# UNITED STATES PATENT AND TRADEMARK OFFICE

APPLICATION NO.	FILING DATE	FIRST NAMED INVENTOR	ATTORNEY DOCKET NO.	CONFIRMATION NO.
10/667,602	09/23/2003	Chang-Seob Kim	61610096US	9753
58027	7590	04/11/2006	EXAMINER	
H.C. PARK & ASSOCIATES, PLC			ALEJANDRO, RAYMOND	
8500 LEESBURG PIKE			ART UNIT	
SUITE 7500			PAPER NUMBER	
VIENNA, VA 22182			1745

<b>Office Action Summary</b>	Application No. 10/667,602	Applicant(s) KIM, CHANG-SEOB	
	Examiner Raymond Alejandro	Art Unit 1745

**Figure 1** below illustrates the specific configuration of the electrode assembly:

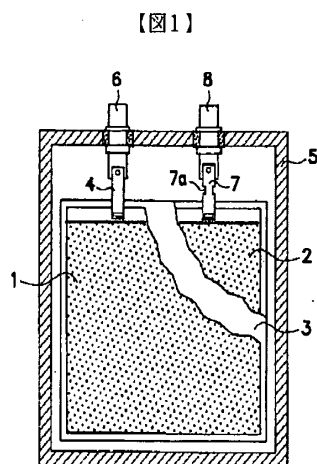
The JP'614 discloses an electrode assembly comprising a positive electrode 1 and a positive electrode lead 4; a negative electrode 2 and a negative electrode lead 7 (P. 0002/ CLAIM 1/FIGURE 1). The electrode assembly is a laminated (stacked) and wound assembly (P. 0011).

A constricted portion 7a is made at the center between an upper and lower side of the negative electrode lead 7 (ABSTRACT). Accordingly, as for the negative electrode, the constricted portion 7a sets a current limit (ABSTRACT/ P. 0014-16).

As shown in **Figure 2**, section 7a has a smaller cross-sectional area than a cross-sectional area of the negative electrode lead (See Figure 2).

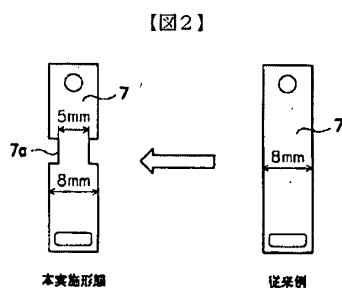
It is apparent from **Figure 2** above that section 7a forms a notch and/or an indentation and/or an angular cut in the edge (See Figure 2).

At least, the cross sectional area near section 7a can be represented by 5 mm x L, while the cross sectional area of the negative electrode can be represented by 8mm x L (See Figure 2).

*Thus, the cross sectional area near section 7a is about 0.625 times that of the cross sectional area of the negative electrode.*
